Final Decision

Planning Commission

File number(s): CU 2019-07, DR 2019-13, EXCP 2019-07, & PP 2019-03

Woodburn High School (H.S.) Addition/Expansion & Redevelopment / "Career & Technical Education (CTE)" Addition

CU-L01

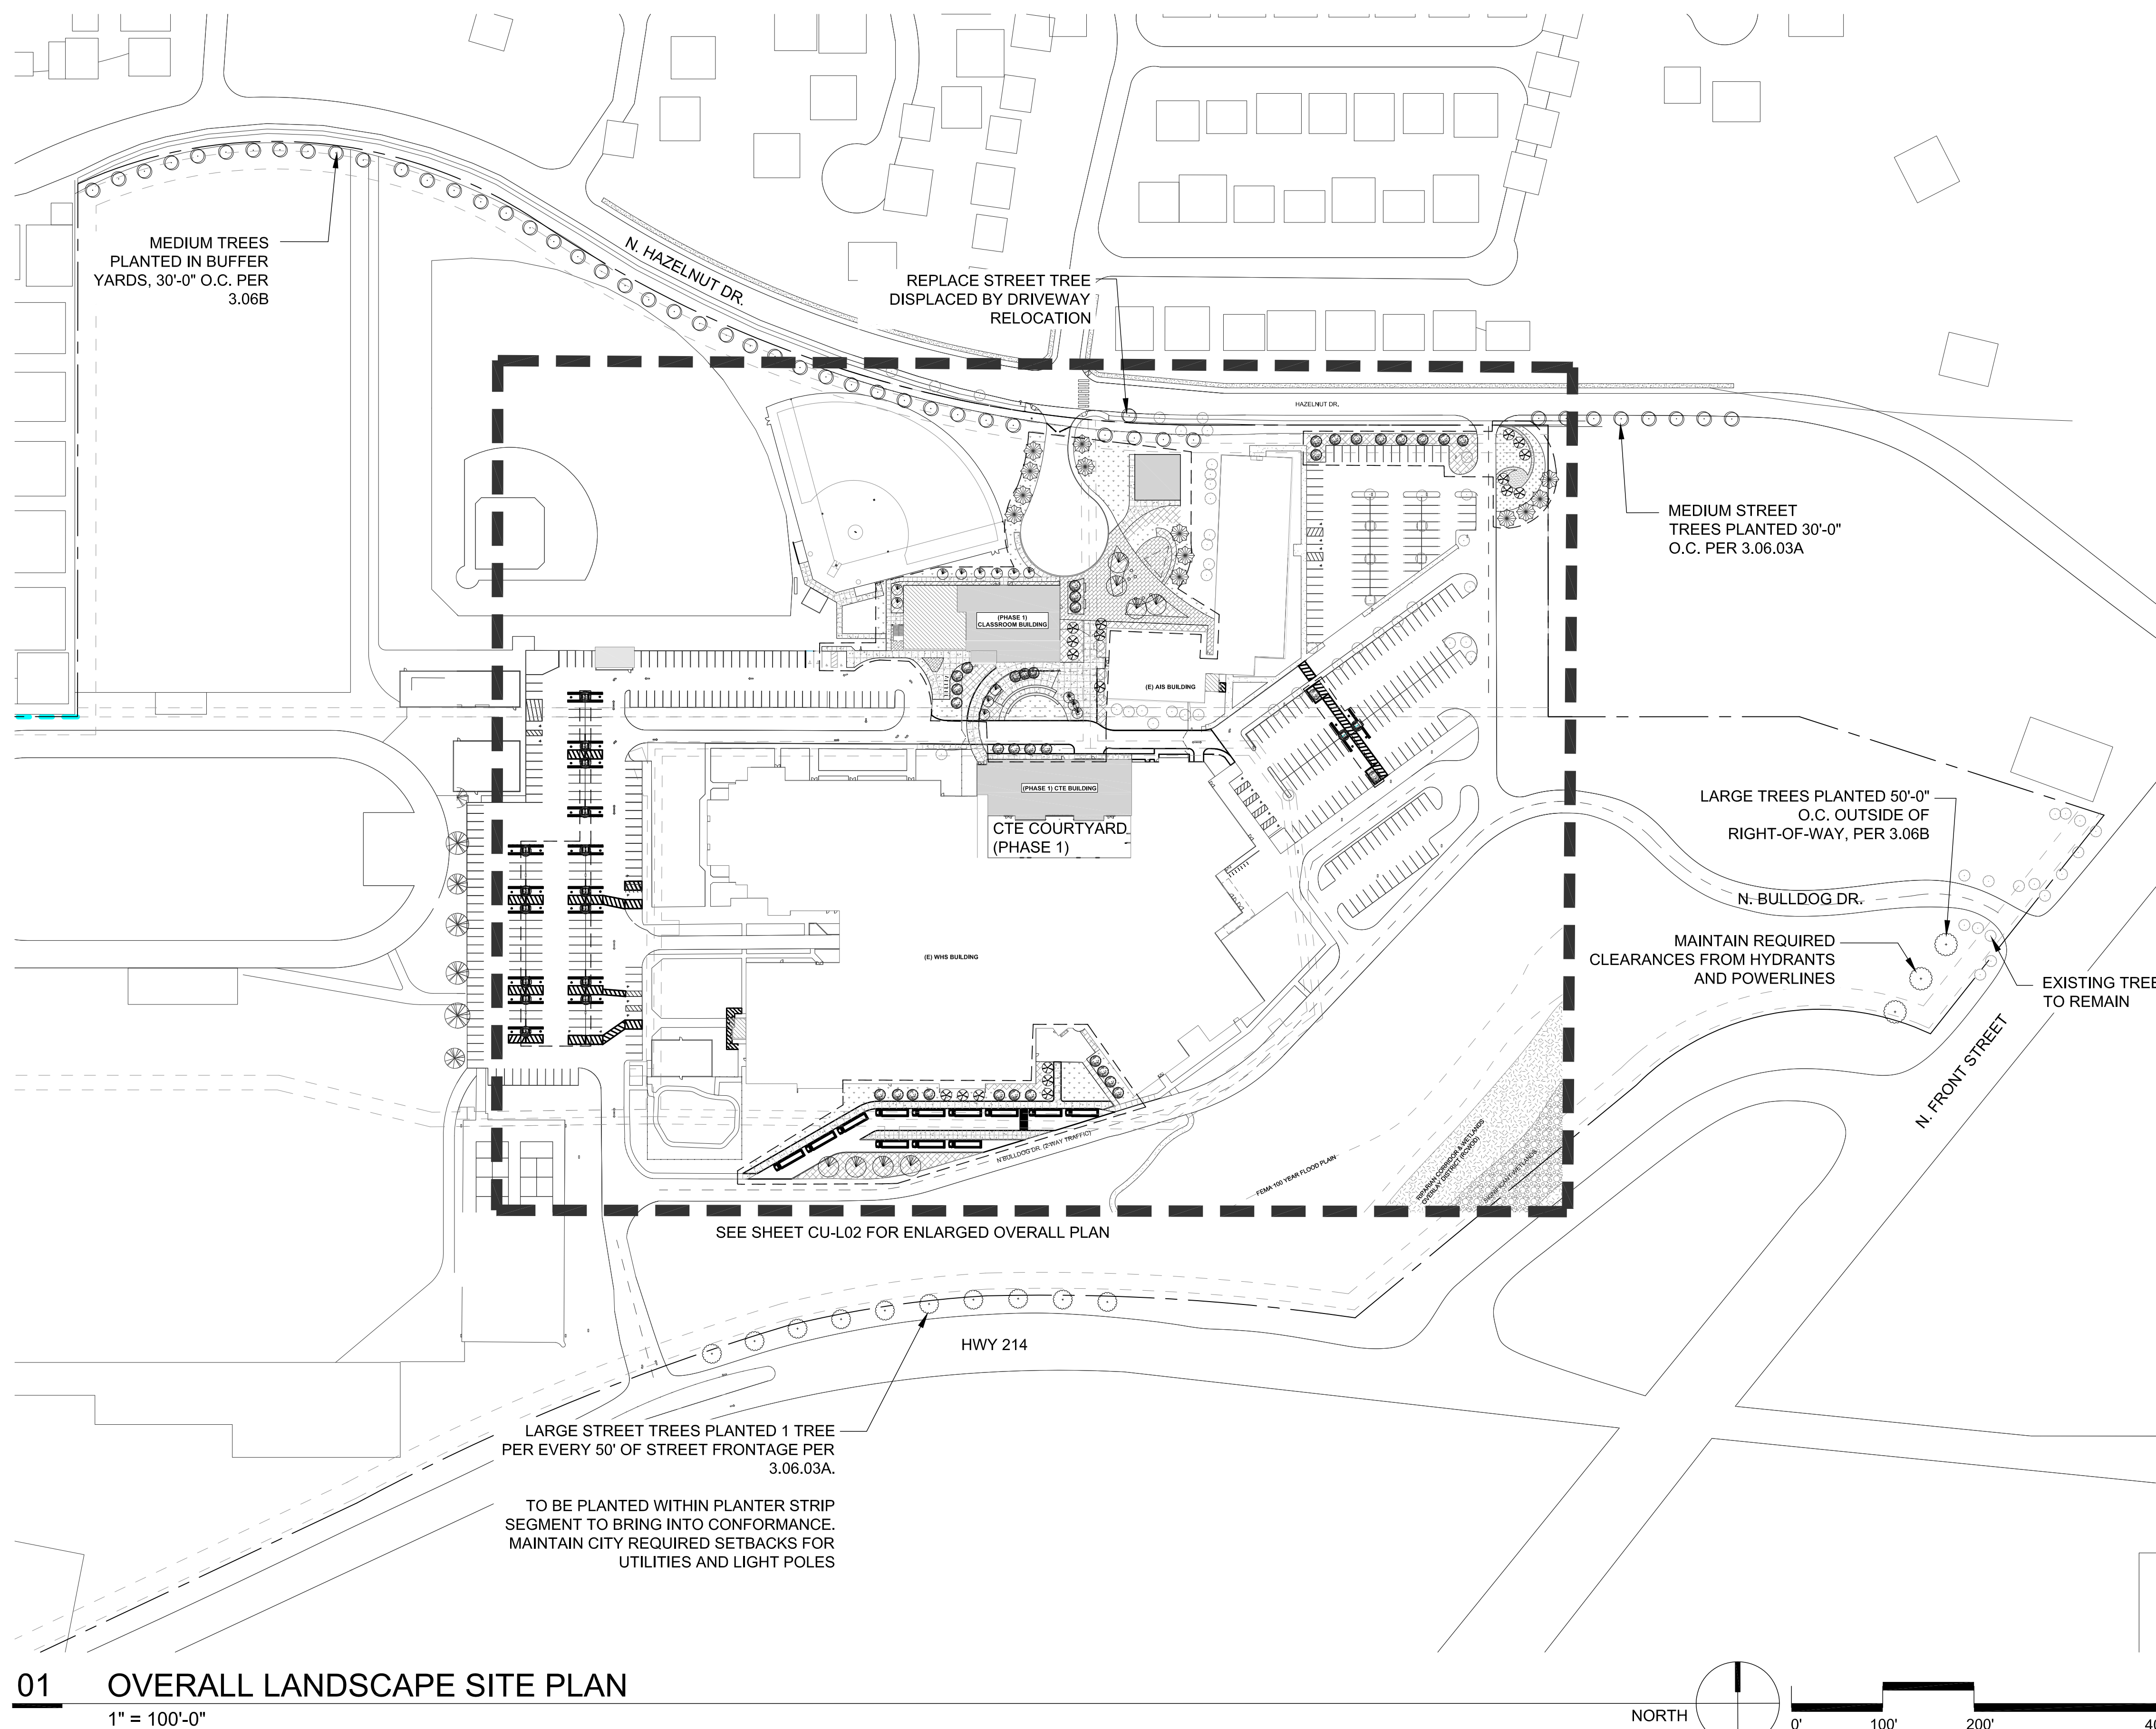
EX2. Hazelnut Drive: The required improvements shall be per the land use review plan set submitted February 4, 2020, Sheets CU-A01 & 3 and L01.

EX3. N. Front Street: The required improvements shall be per the land use review plan set submitted February 4, 2020, Sheets CU-A01 & L01.

EX4. Highway: The required improvements shall be per the land use review plan set submitted February 4, 2020, Sheets CU-A01 & L01.

1 NORTH ELEVATION - ZONE A - CONDITIONAL USE
1/8" = 1'-0"

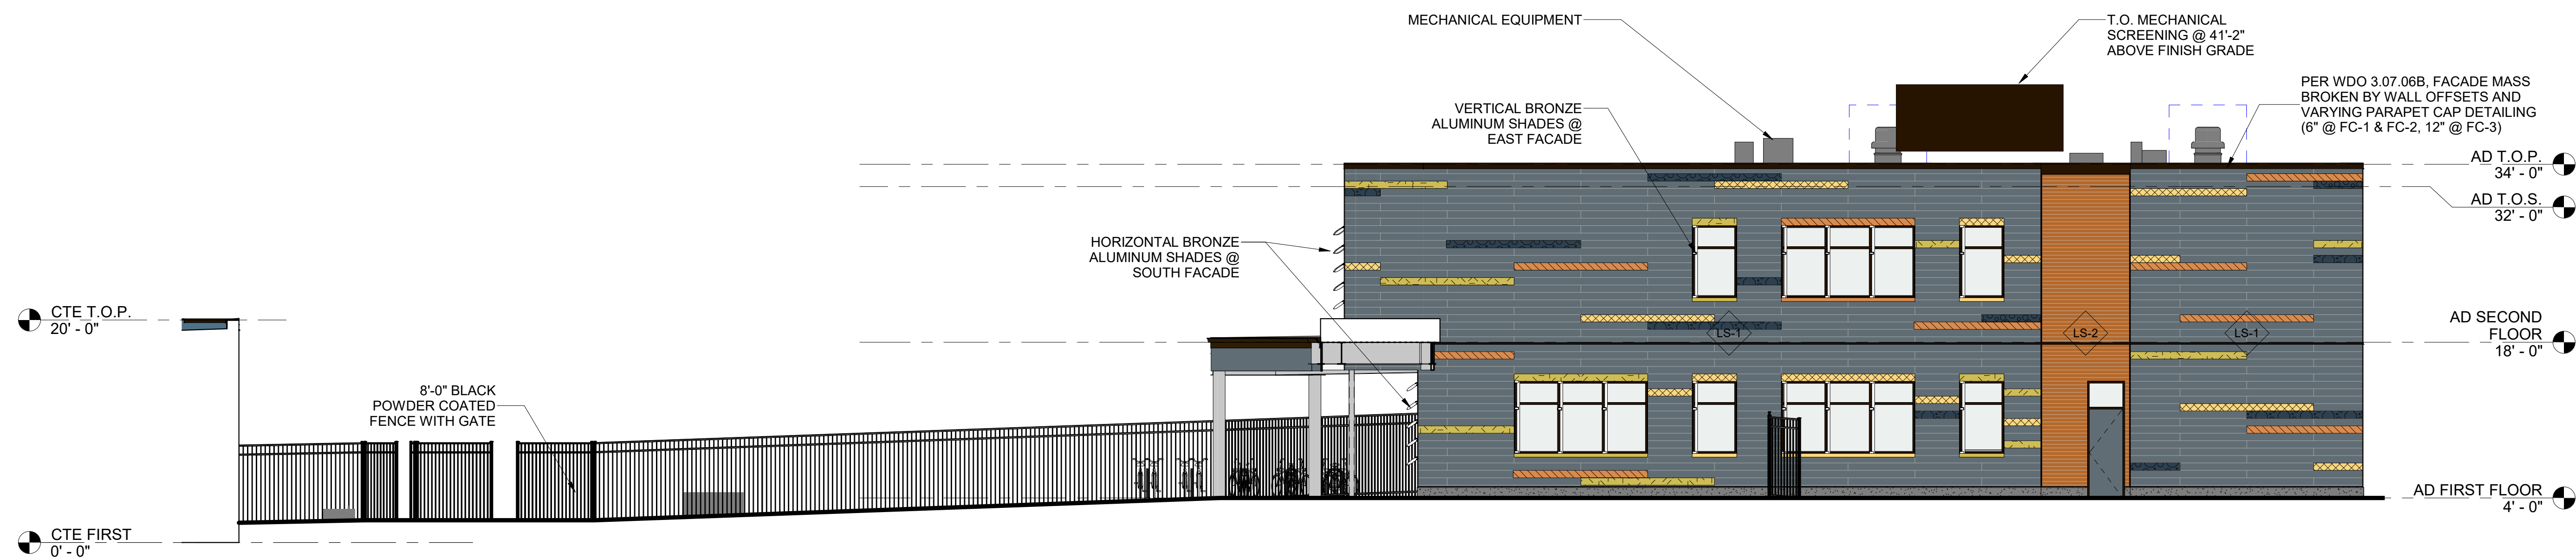
C14. Architecture: As proposed, the north outbuilding labeled as “classroom building” shall meet or exceed the window area percentage provision of WDO 3.07.06B.2b(1) on the north façade that faces Hazelnut Drive.
